Docket Item # 1 & 2
BAR CASE # 2013-0042/0043

BAR Meeting
March 20, 2013

ISSUE: Permit to Demolish/Encapsulate and Addition/Alterations

LOCATION: 317 South Union Street

EXIST'G FIRST FLOOR PLAN
3/16" = 1'-0"

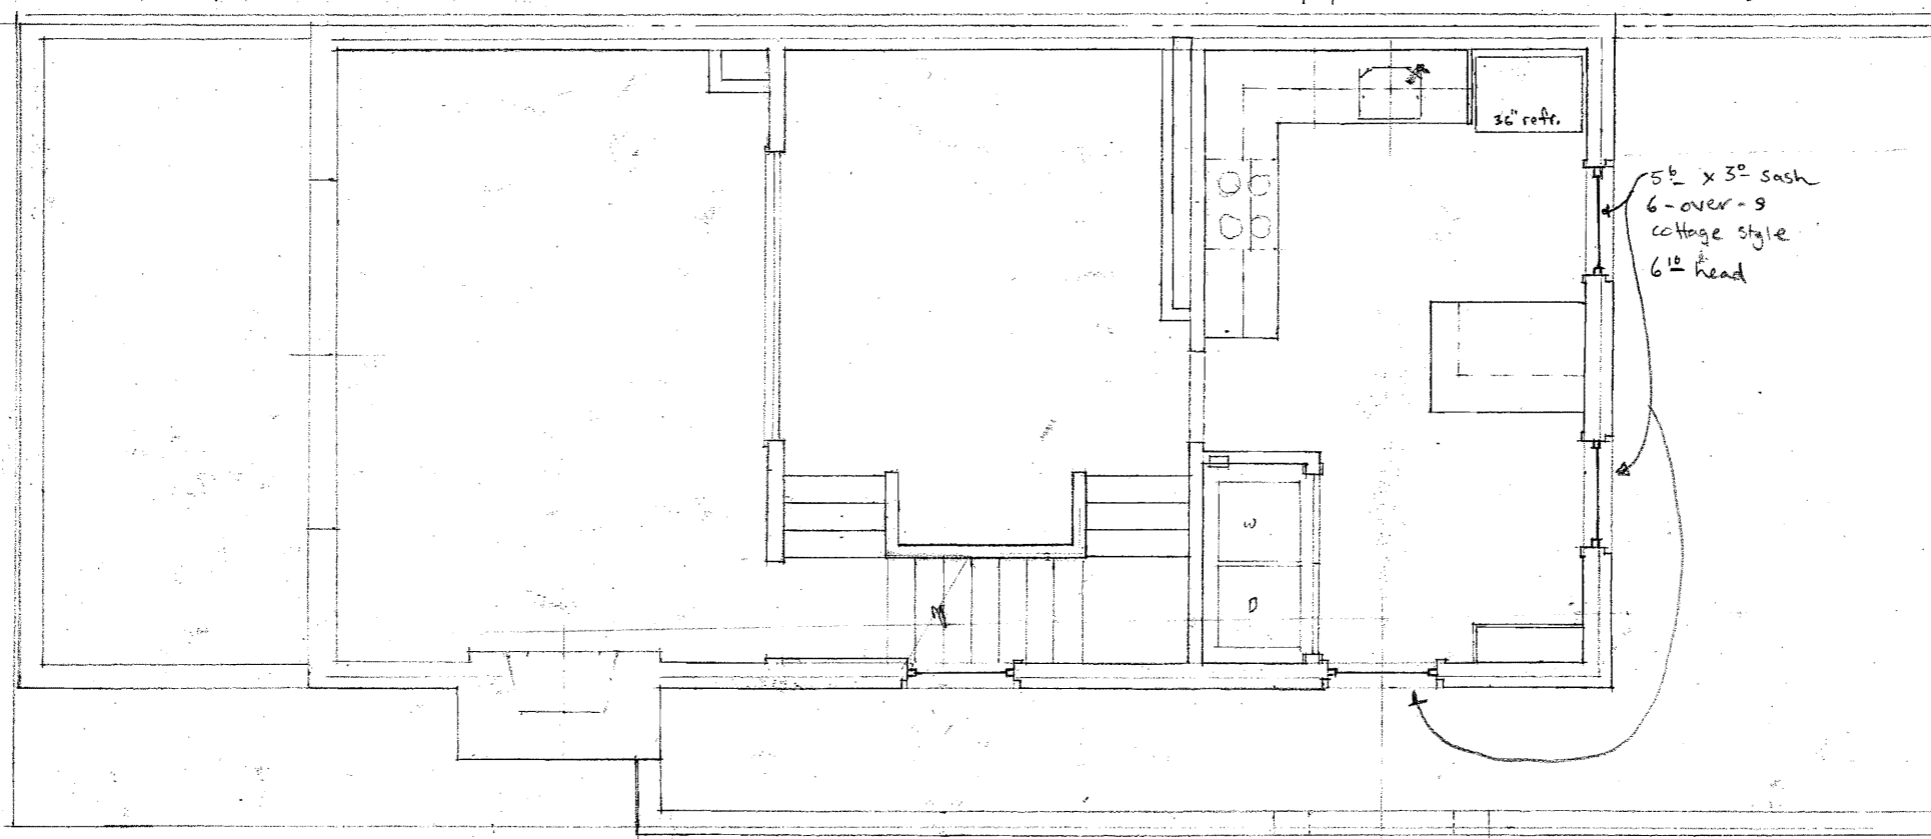
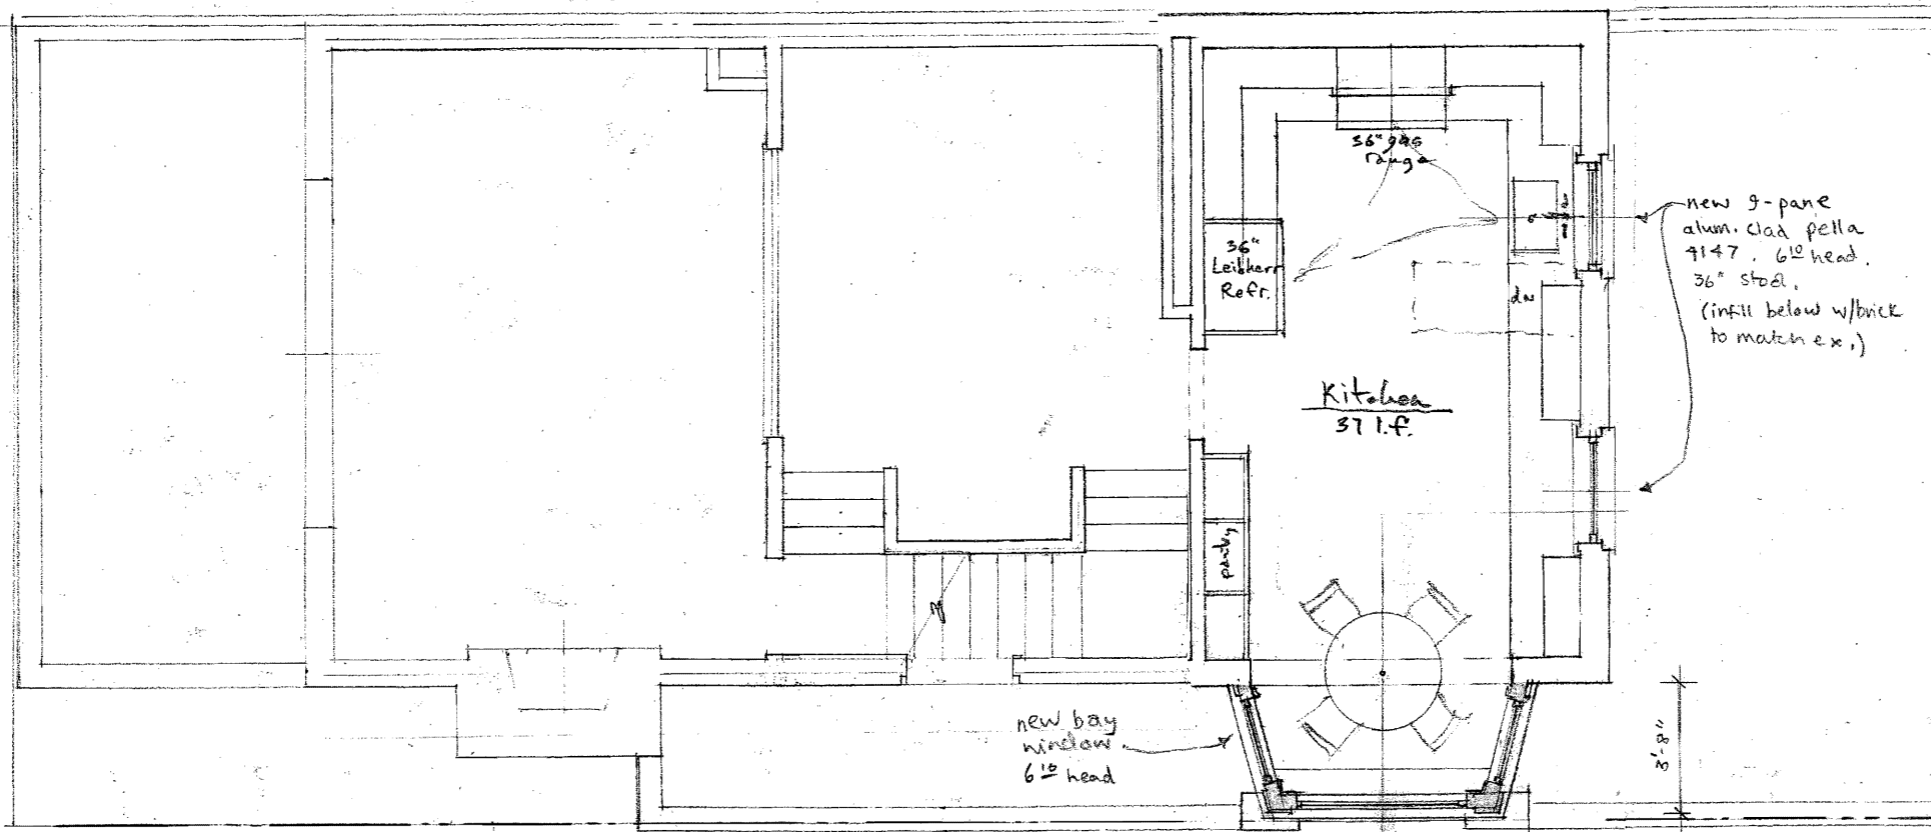
Regarding the new bay window addition, Staff has no objection to the proposed second story bay window as it is not on the street-facing elevation and is well detailed. Although it is unusual to anchor a bay window on the brick piers of a brick wall and the result will somewhat obscure the front entrance, staff finds that it is a successful design, noting that the front entrance of this townhouse is not particularly prominent in its current form.

- C-1 Applicant must indicate average finished grade on the plans.
- C-2 The proposed AC unit and bay window area are located in open space that is less than 8' by 8' and does not meet the technical requirement to be counted as open space. Open space was calculated for the entire development when the townhouses were originally approved.

(A) EAST ELEVATION ~ West similar @ altered roof
3/16" = 1'-0"

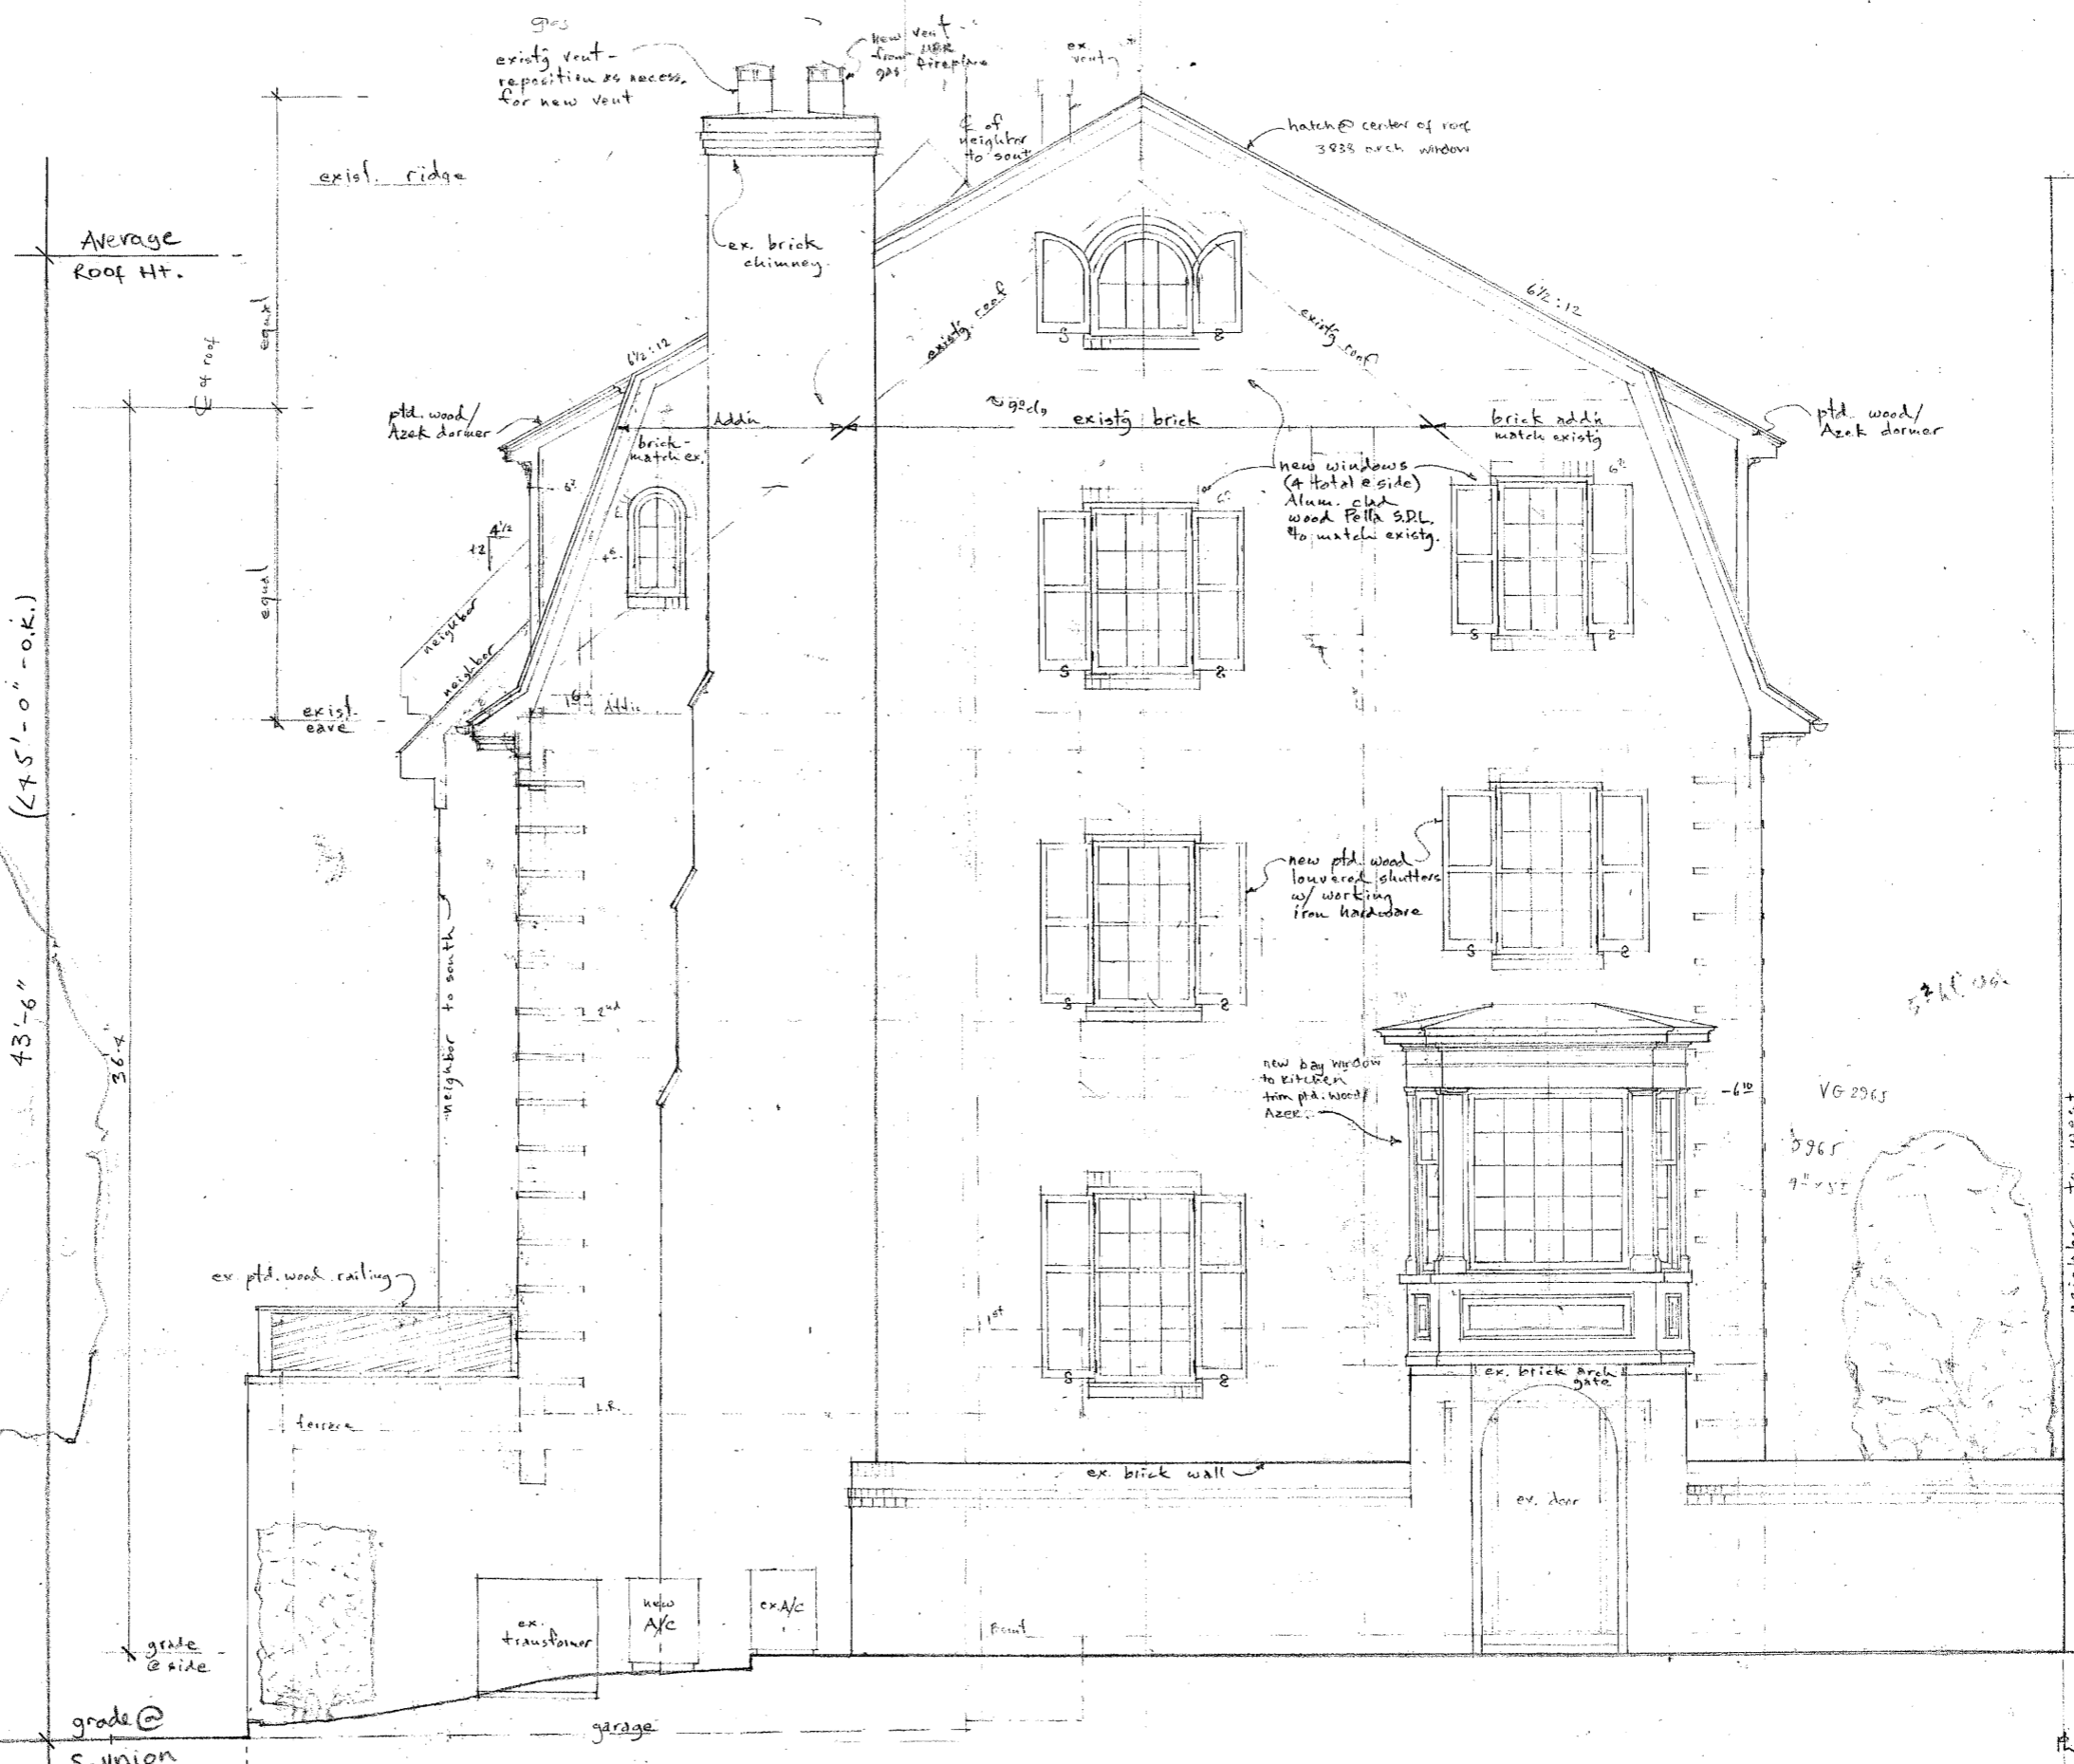
respectful of the existing structure and which seek to be background statements or which echo the design elements of the existing structure.” While the Ramsay house and the Mayor Hooe house are the most prominent examples, there are several historic gambrel roofs found nearby in the district. There are a variety of different roof forms, roof slopes and architectural detailing throughout the Waterford development, so altering this particular townhouse’s roof will not result in an imbalance of scale or design detail with respect to the rest of the development. The use of a gambrel roof form allows for an addition with a modest expansion of the existing building envelope. While it could potentially be overwhelming with respect to scale and massing to build out every upper half story in the district, Staff finds that it is an appropriate design solution in this particular circumstance and does not believe that it will not overwhelm the existing townhouse nor the surrounding buildings. Many of the buildings in the historic district have evolved and grown over time and the changes proposed to this building are not unlike historic changes found throughout the district, such as the Second Empire-zation of the Delaney Realty building at 131 North Washington Street, complete with the addition of a mansard roof and a pronounced bracketed cornice. The gambrel roof form (the English term for the French Second Empire style Mansard roof) substantially improves the architectural interest of this simple, highly visible north elevation and is a better termination for this string of late 20th century townhouses on South Union Street. The current submission includes a slightly steeper slope for the gambrel roof and Staff supports this change.

- C-3 Proposed height will be greater than 35.00 feet. The RM zone (3-1106(D)) allows a height increase if the ridge is parallel to the street and the slope of the roof is compatible with the neighboring buildings. The BAR must determine the roof slope compatibility to grant the height increase to 45 feet.

SHEET
9

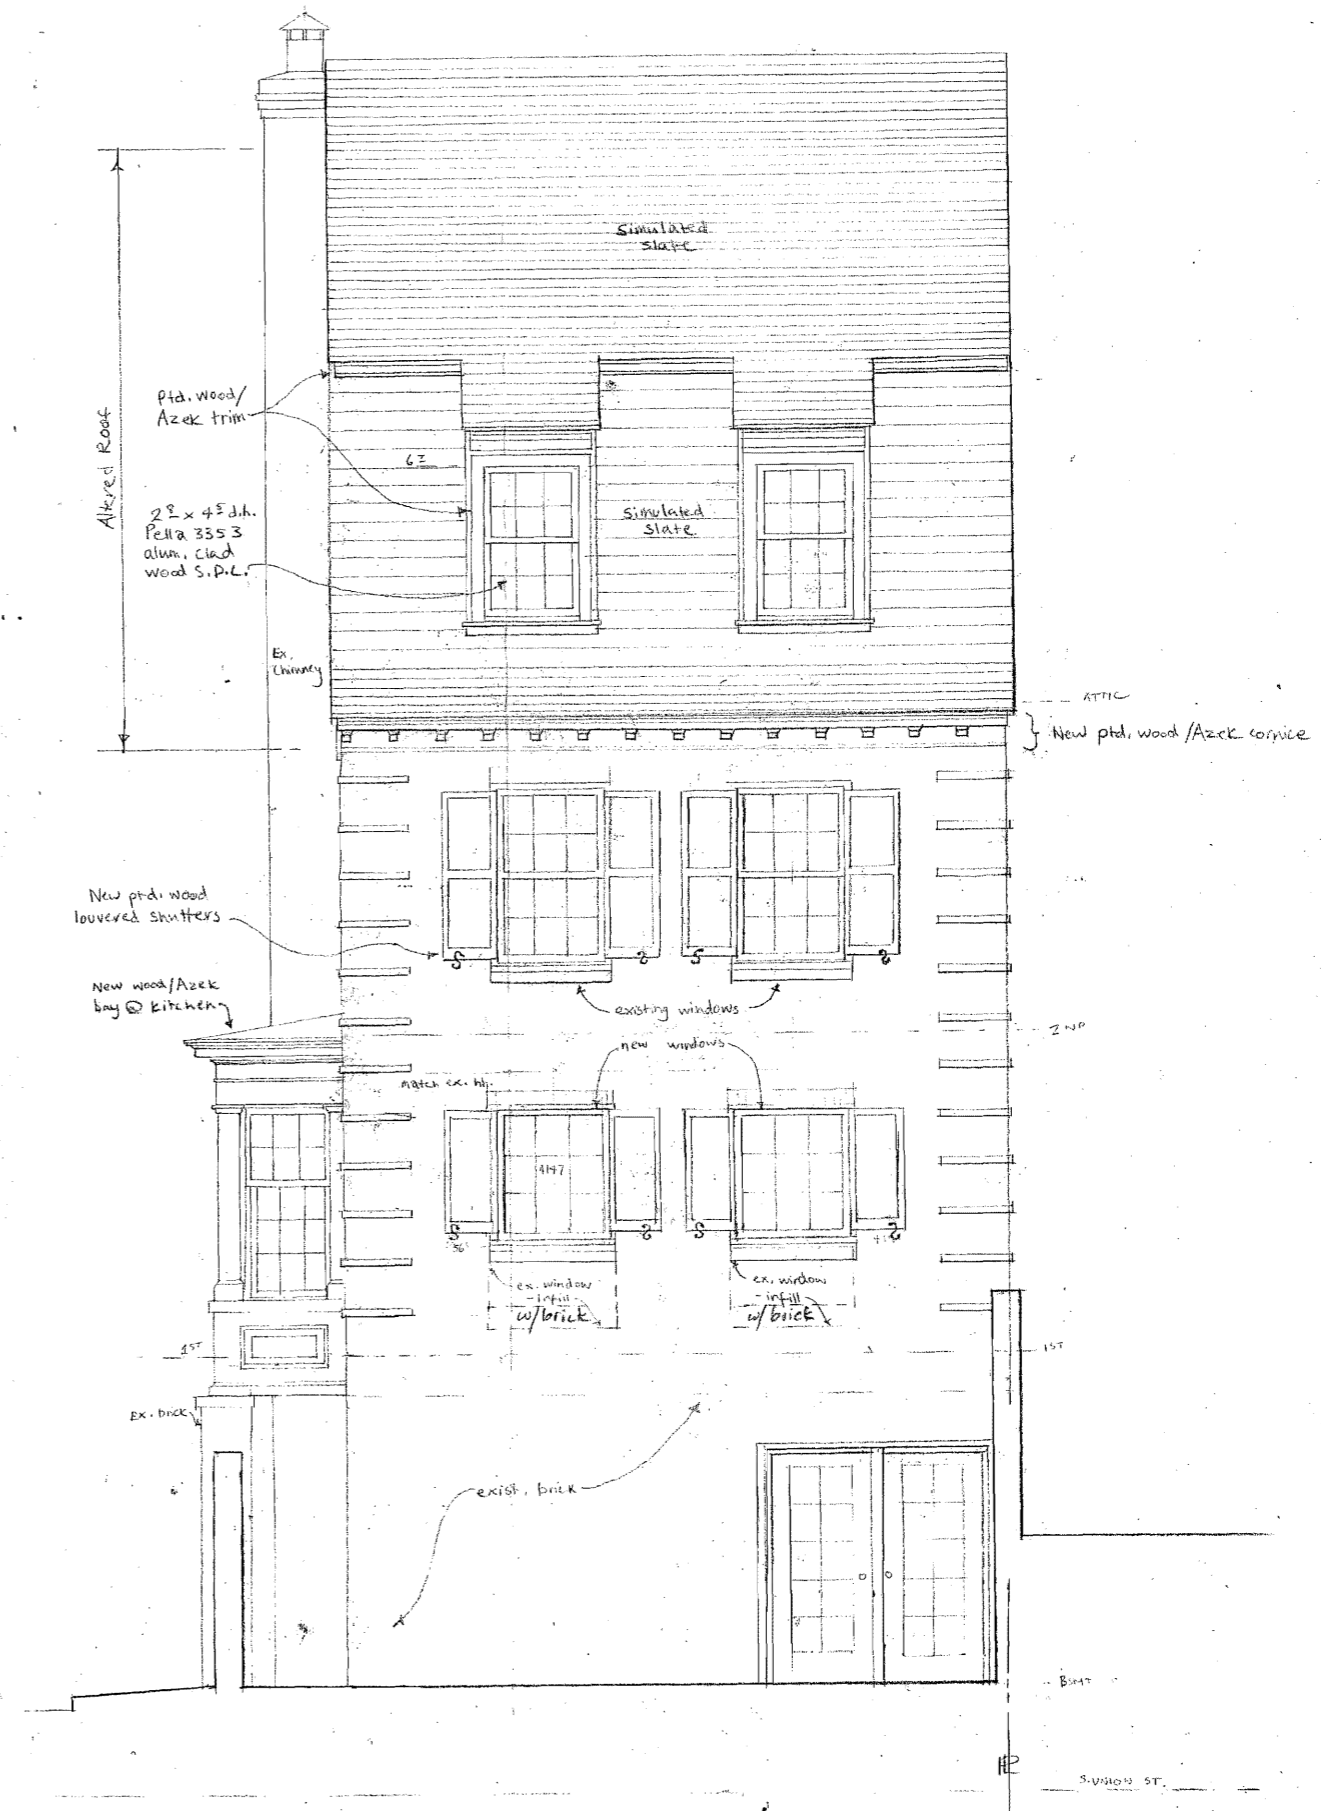
The changes to the two west elevation windows are appropriate and consistent with the evolution of rear elevations as interior functions evolve.
